WELLINGTON SCHOOL BUILDING COMMITTEE
MINUTES
December 11, 2013
School Administration Building Conference Room
7:30 AM

Subject: Wellington School Acoustics Assessment - DRAFT
Wellington School
Belmont, Massachusetts
Acentech Project No.: 623729

Standard Doors
With Gaskets

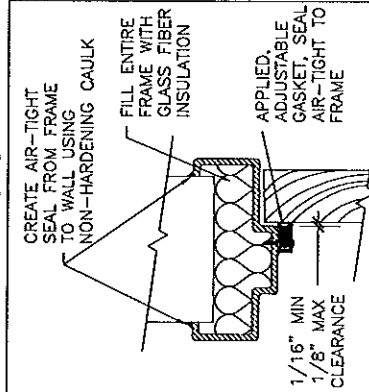
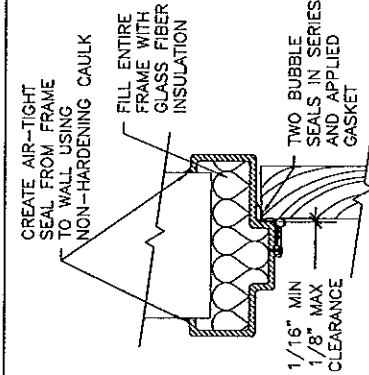
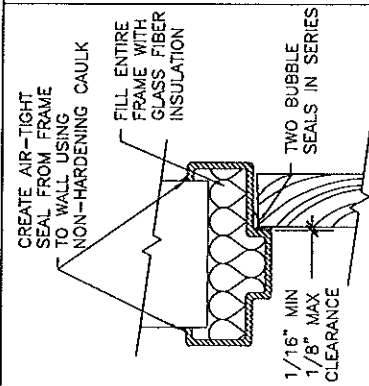
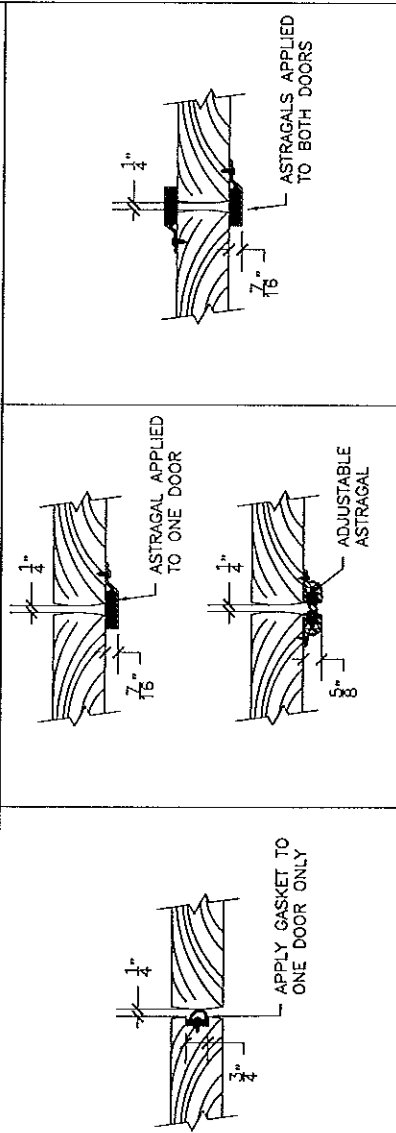
To improve horizontal sound isolation between classrooms, full perimeter, adjustable neoprene gaskets should be installed at the communicating doors. These gaskets should include a bottom seal and seals on both jamb and head. Best results will be obtained if the gaskets shown for "Type 2" or "Type 3" doors on the attached detail sheet are employed.

HEAD AND JAMB GASKETS		
PEWKO	ZERO	NATIONAL GUARD
TYPE 1	S88	188
TYPE 2	S88+313N	188+328 5050+137N
TYPE 3	379PK	870 141NB

ASTRAGAL GASKETS		
PEWKO	ZERO	NATIONAL GUARD
TYPE 1	313N	53-M
TYPE 2 & 3	351PK	555 140S
TYPE 2 & 3 OVERLAPPING	375	140-M 108N

BOTTOM GASKETS		
PEWKO	ZERO	NATIONAL GUARD
TYPE 1	314AN	52
TYPE 2	314AN	52
TYPE 3	314AN	52

THRESHOLDS		
PEWKO	ZERO	NATIONAL GUARD
TYPE 1	151 / 270	540 410 / 411
TYPE 2	151 / 270	540 410 / 411
TYPE 3	151 / 270	540 410 / 411

1. FOR TYPE 1 AND 2 DOORS, WHERE A THRESHOLD IS NOT PERMITTED, USE AN AUTOMATIC DROP BOTTOM SEAL.
2. TYPE 3 DOORS, WHERE A THRESHOLD IS NOT PERMITTED, USE CAM LIFT HINGES.

- NOTES:
1. DOORS SHOULD BE SOLID CORE WOOD OR STEEL STIFFENED WITH FIBERGLASS FILL WITH 16GA. FACE SHEETS.
 2. FILL FRAMES WITH GLASS FIBER AT GYPSUM BOARD OPENINGS AND GROUT-FILL FRAMES AT MASONRY OPENINGS.
